THE  STAR

MODIFICATION 13 PLANNING SUBMISSION

FIRE ENGINEERING
ASSESSMENT

Figure 13: Section showing location of car stacker levels in relation to lower portion of building

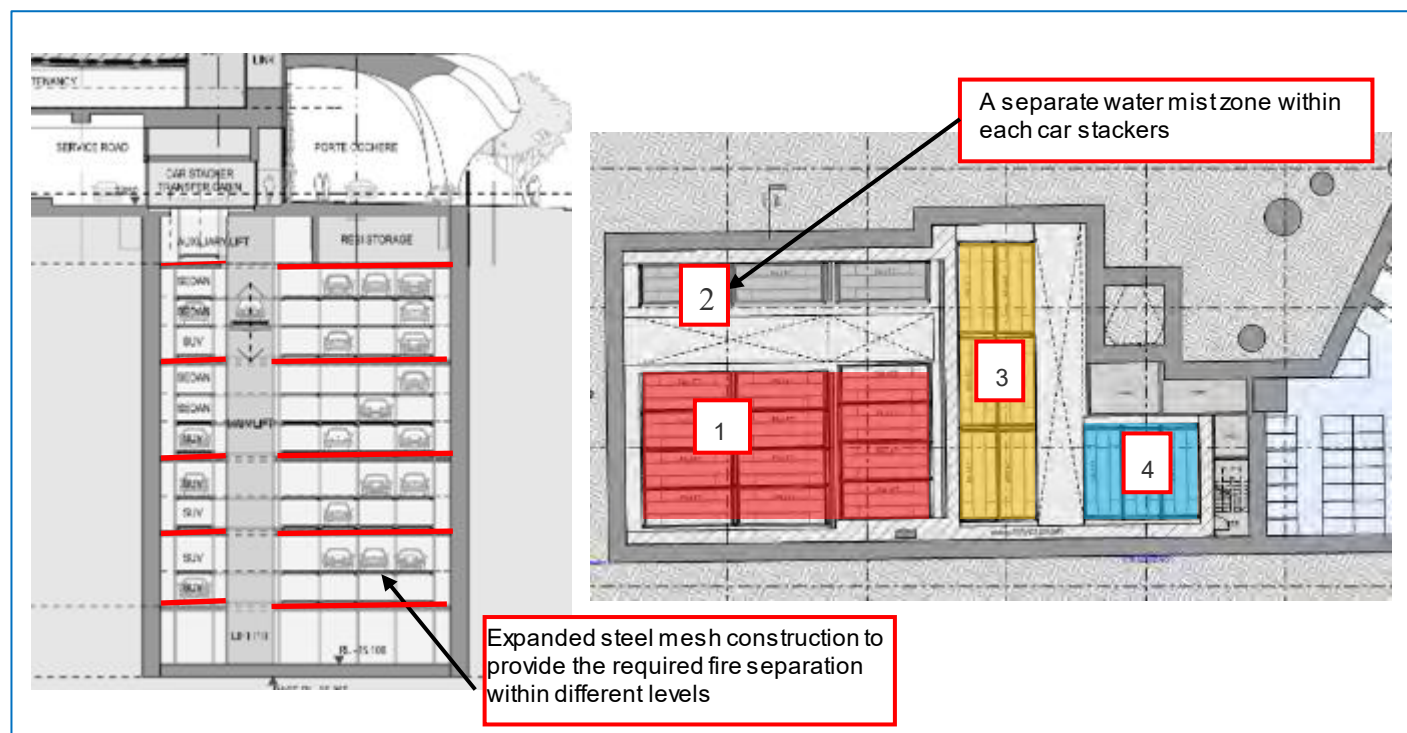
FRNSW Comment: FRNSW recommends the water mist system zoning (with the use of flow switches) should be considered in conjunction with fire brigade access points to enable accurate identification of the location of the fire and appropriate access point.
